ZONING REVIEW SHEET

CASE: C814-06-0202

ADDRESS: 1703 River Hills Road

TO: PUD (Planned Unit Development)

**THE PIER
REDEVELOPMENT
PLAN**

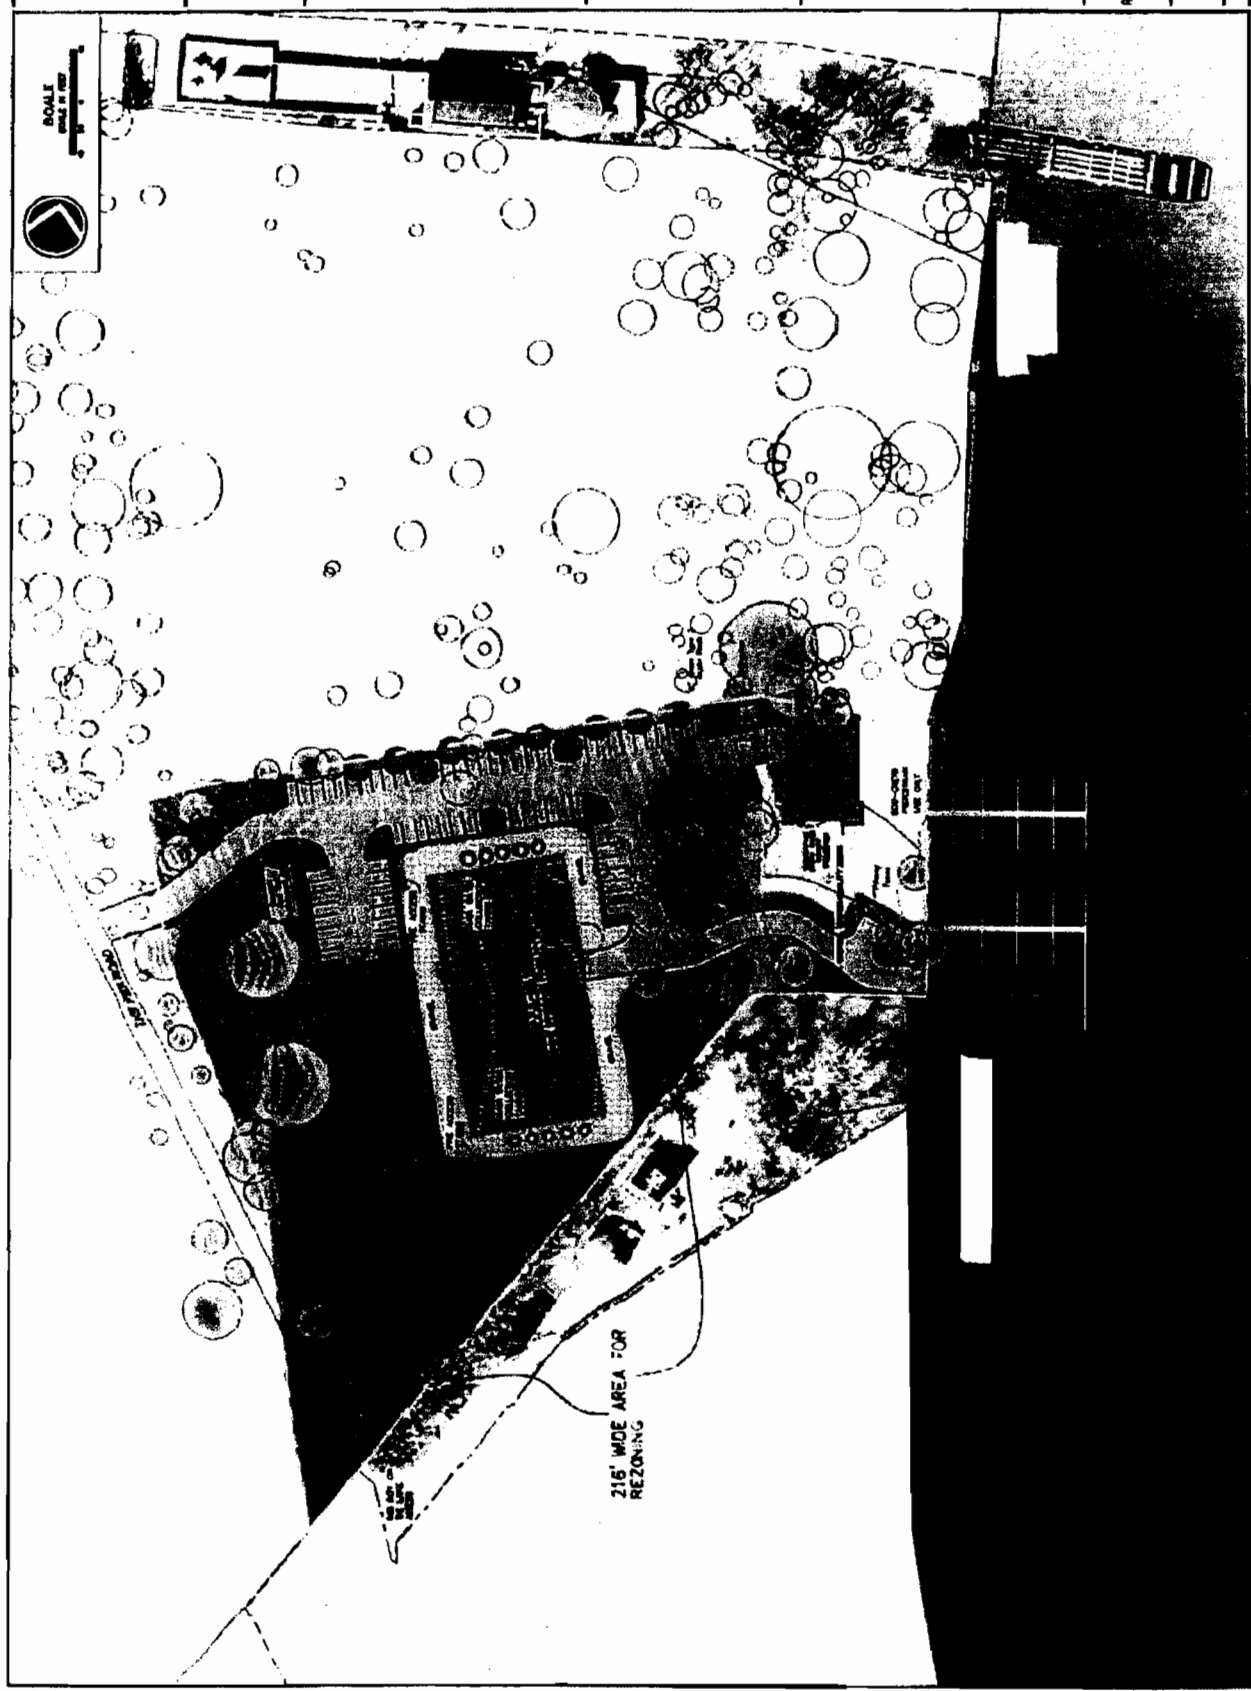
- DC 1. Please delineate the 25 and 100-year floodplain on the land use plan. The project is requesting a variance from LDC § 25-7-92 (Encroachment on floodplain prohibited) to allow construction within the 100 year floodplain. However, the code reference is concerned with construction in both the 25 year and the 100 year floodplain. The proposed development in the 100 year floodplain will need to demonstrate the requirements listed in § 25-7-92 (C)(1)(a)-(b) are met. The proposed development located within the 25 year floodplain must meet the requirement in § 25-7-96 (Exceptions in the 25 year floodplain).
- DC 2. This comment will be address at the site plan stage. The proposed project will need to dedicate an easement for stormwater flow to the limits of the 100-year floodplain as required per the LDC § 25-7-152 (Dedication of easements and rights-of-way).

- ZN 7. On the revised PUD Land Use Plan, please define modifications to compatibility standards and depict the proposed locations where the modification to compatibility setbacks is sought.

The land plan does not depict areas where waiver of compatibility standards is sought. There are existing single-family residences south of the property that would trigger compatibility standards at the time of redevelopment.
